**DEXUS QUARRYWEST PROJECT (SSD 6801) – SECTION 96 MODIFICATION (MOD 3) –  
RESPONSE TO SUBMISSIONS**

**Re: SSD 6801 Mod 3 QuarryWEST Project, DEXUS Estate, Warehouse and Distribution Centre,  
Reconciliation Road, Pemulwuy, section 96 modification application**

**Re: Lot 18 DP 270644, Greystanes Southern Employment Land (Boral Land)  
Section 96 Application SSD\_6801**

Street Elevations

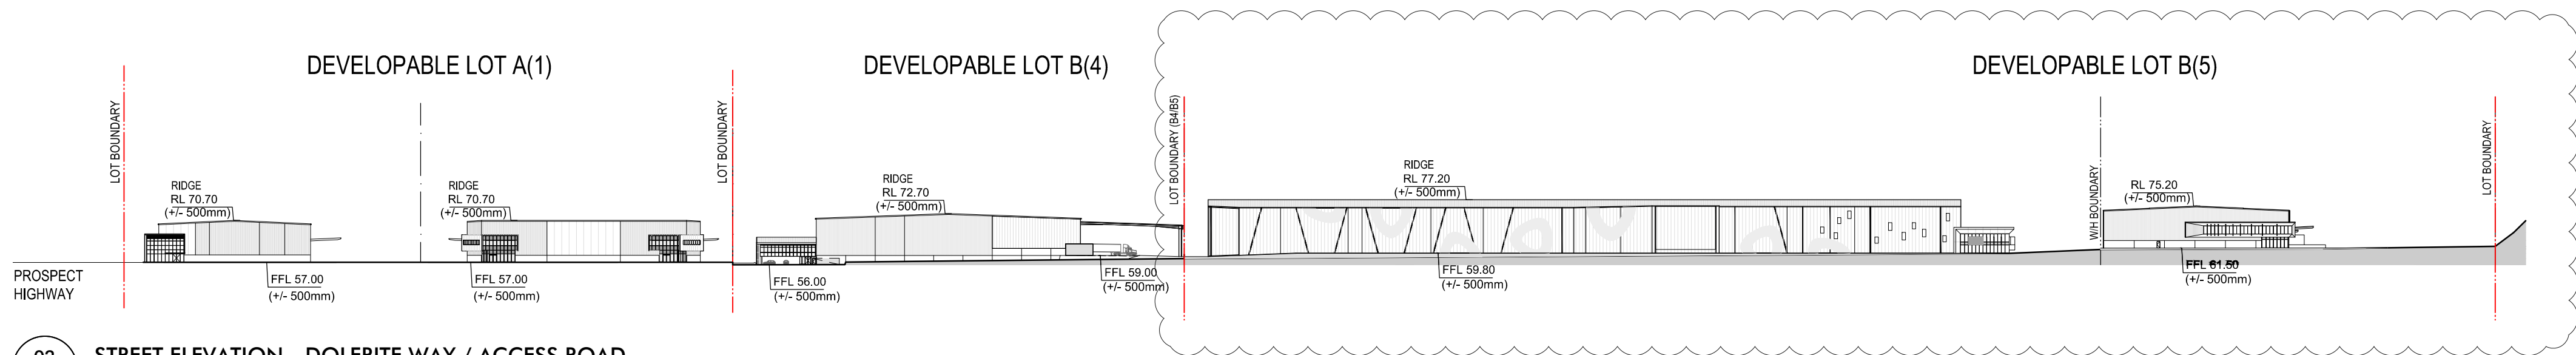
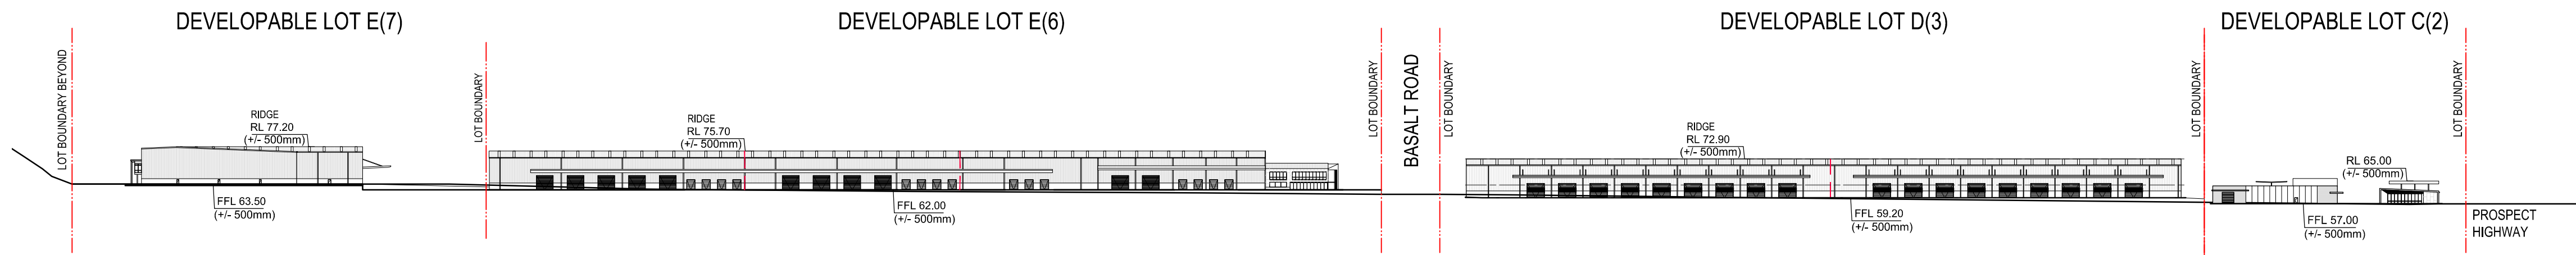
- updated estate elevations and sections showing the proposed modifications; and
- revised versions of stormwater plans (DA41 and DA 46) to correct revision and date details.

The updated estate elevations and sections are attached as **Attachment B**, and the updated stormwater plans are attached as **Attachment C**. It is noted that all of the civil/stormwater plans required updating to correct the revision details, and as such the complete set of civil plans (and review report) is provided in Appendix C.
